## Proposed Changes for SPI-4

00-246r7

Paul Aloisi TI

The driver/receiver electrical changes proposed for SPI-4

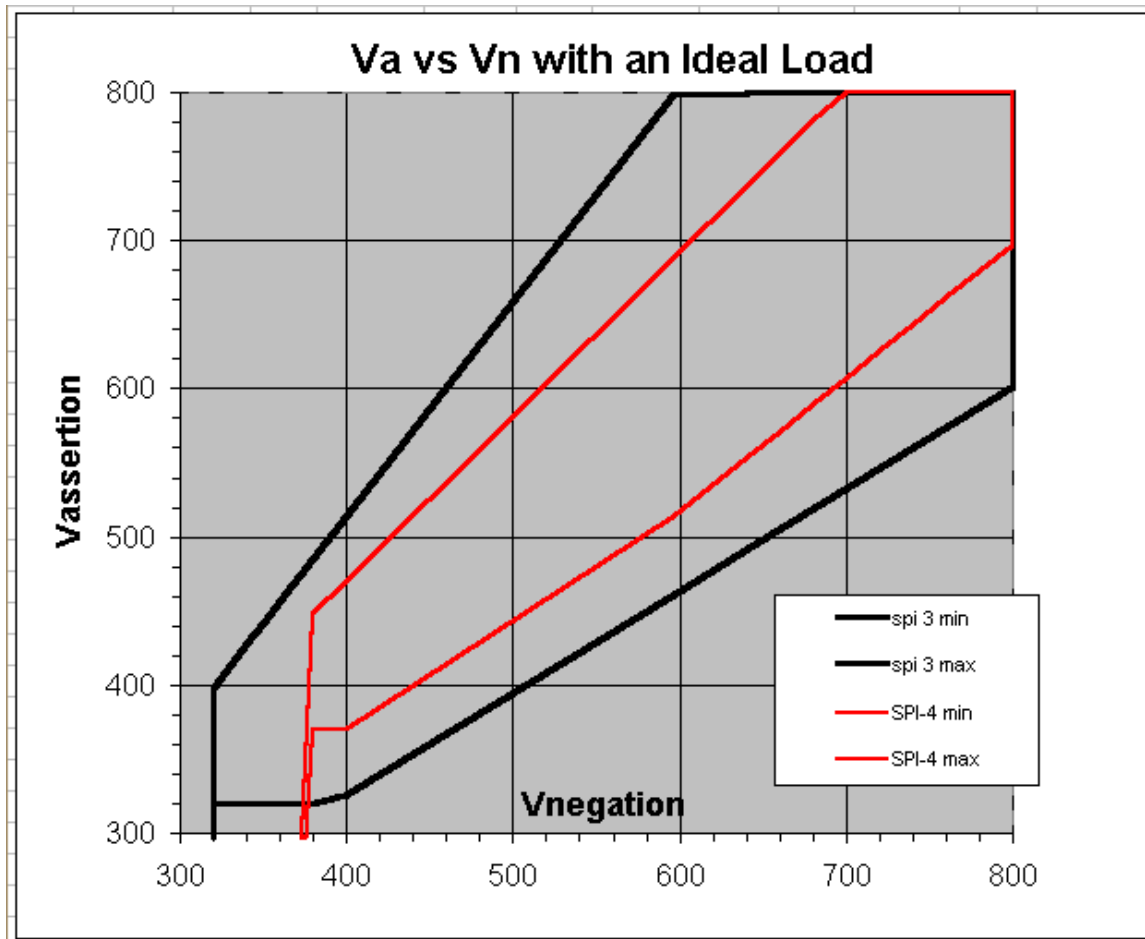
The driver asymmetry equation from the July meeting is wrong. The equations should be  $V_a = (0.9 * |V_n|) - 23$  Minimum and  $(1.11 * |V_n|) + 26$  Maximum

Table A.2 Assertion VA equation for Fast-160 must change to  $V_a = (.9 * |V_n|) - 23$  Minimum and  $(1.11 * |V_n|) + 26$  Maximum

Change fall back to 50 to 66% from 60 to 78%

Fast-160 LL Receiver Mask, during the data transitions  
 +/-1.1 volt maximum with reflections

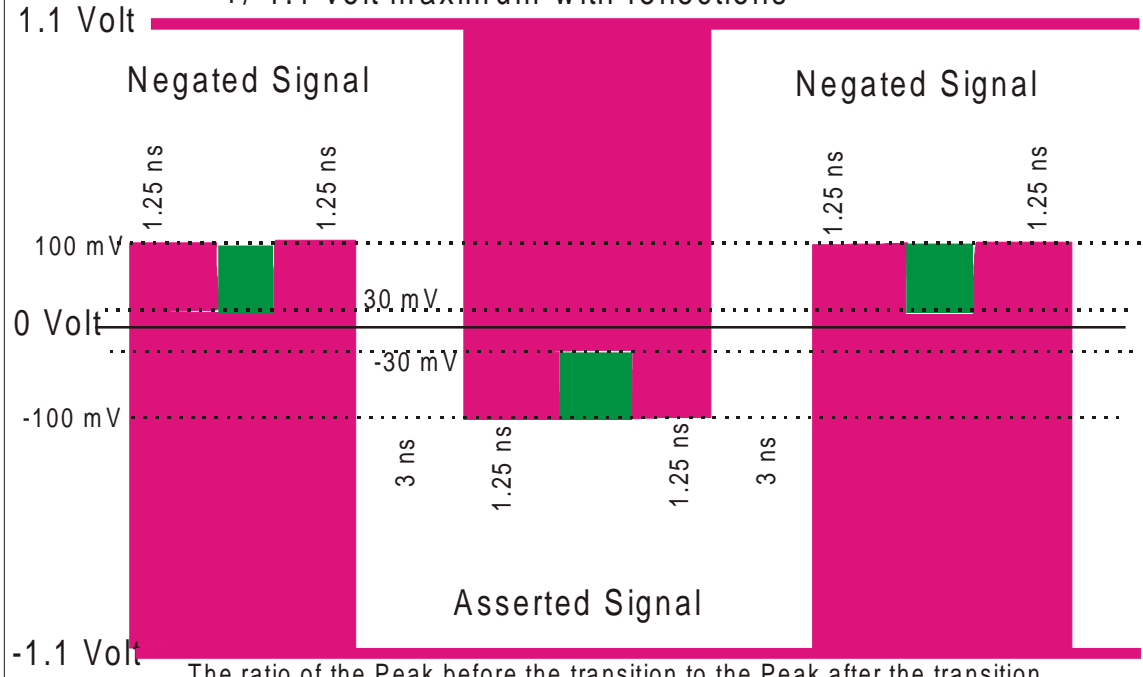
Figure 51 and 52 Receiver Mask paced data transfer  
needs to be different for the 3 camps, there should be 3 new masks

The ratio of the Peak before the transition to the Peak after the transition in the 1.25 ns range shall not exceed 4 to 1.

Fast-160 Receiver Mask NL for isolated assertion or negation pulses, during the data transitions +/-1.1 volt maximum with reflections

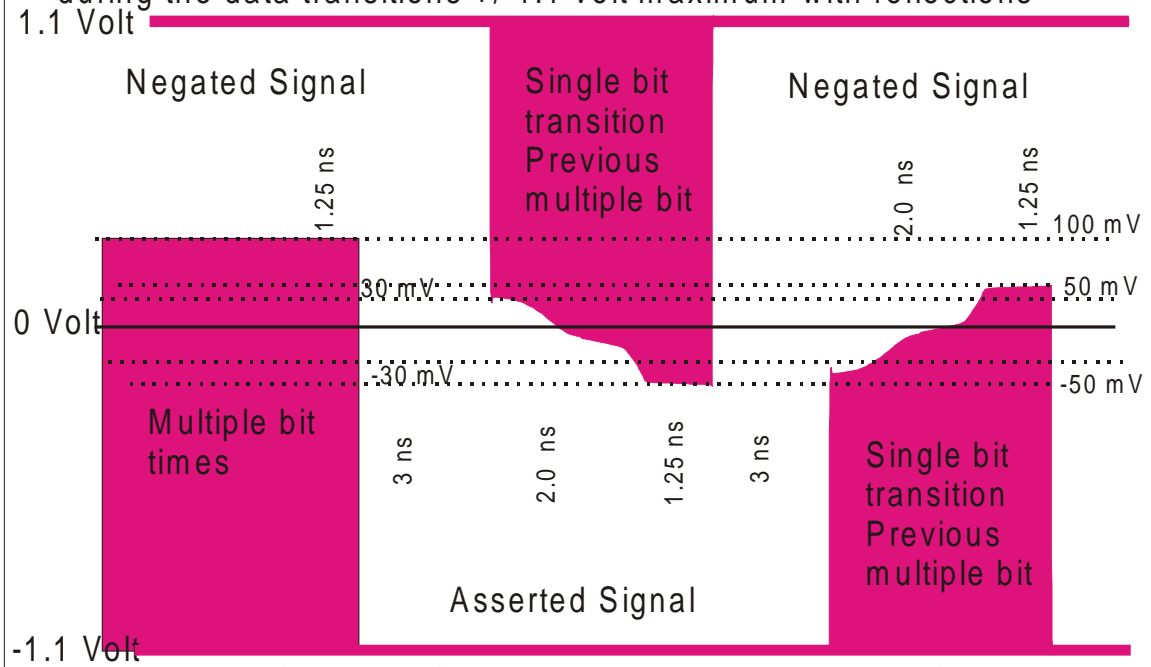
The ratio of the Peak before the transition to the Peak at the end of the next bit time in the 1.25 ns range and the transition shall be at least 200 mV..

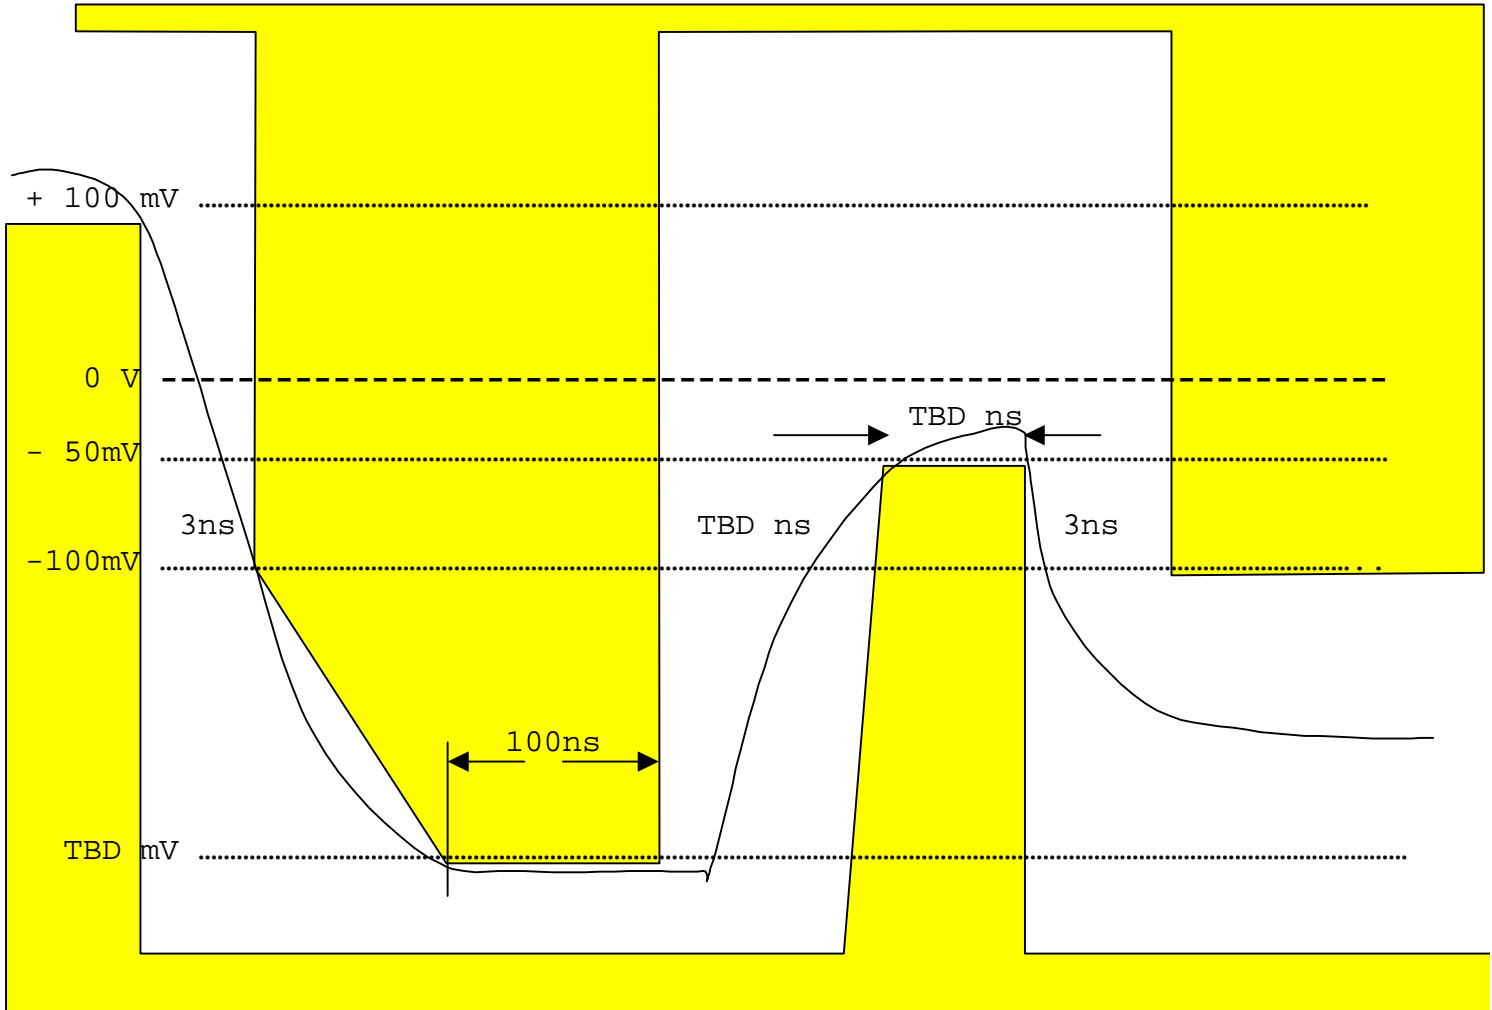
Replaced with Dick Uber's drawing 00-347
